TRANS/WP.29/805
3 August 2001

DRAFT SUPPLEMENT 2 TO THE 05 SERIES OF AMENDMENTS
TO REGULATION No. 83

(Emissions of M_1 and N_1 categories of vehicles)

Figure 8/1: Parameters measured during emissions test during and between cycles where regeneration occurs (schematic example, the emissions during 'D' may increase or decrease)

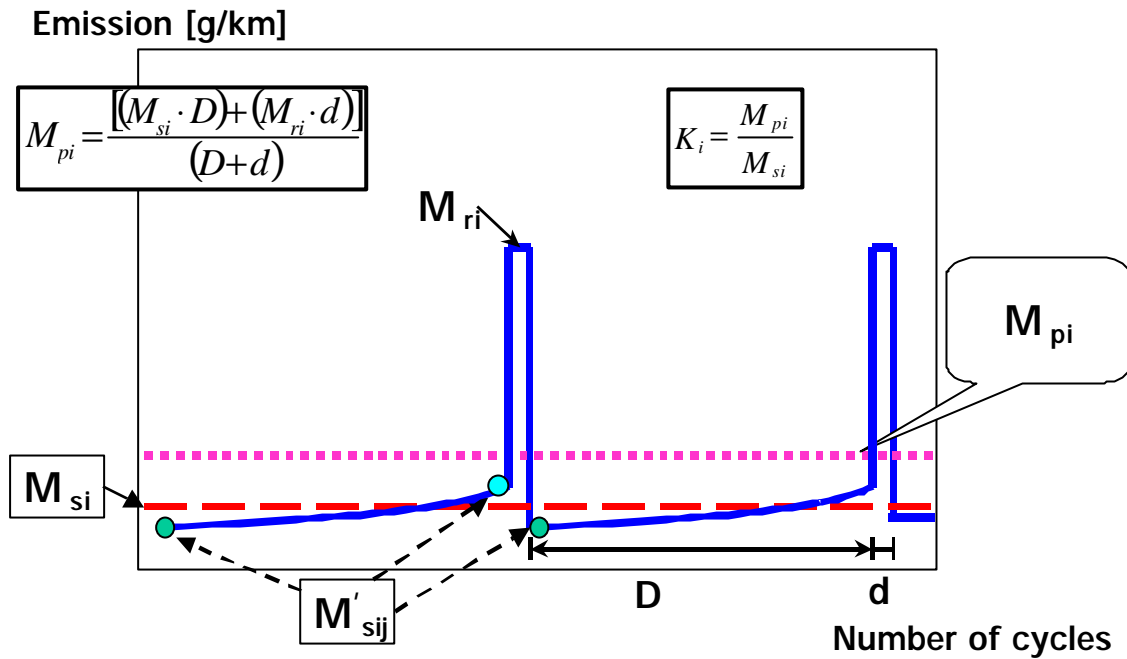
For exemplary illustration of measurement parameters see figure 8/1.

3.4. Calculation of the regeneration factor K for each pollutant (i) considered

$$K_i = M_{pi} / M_{si}$$
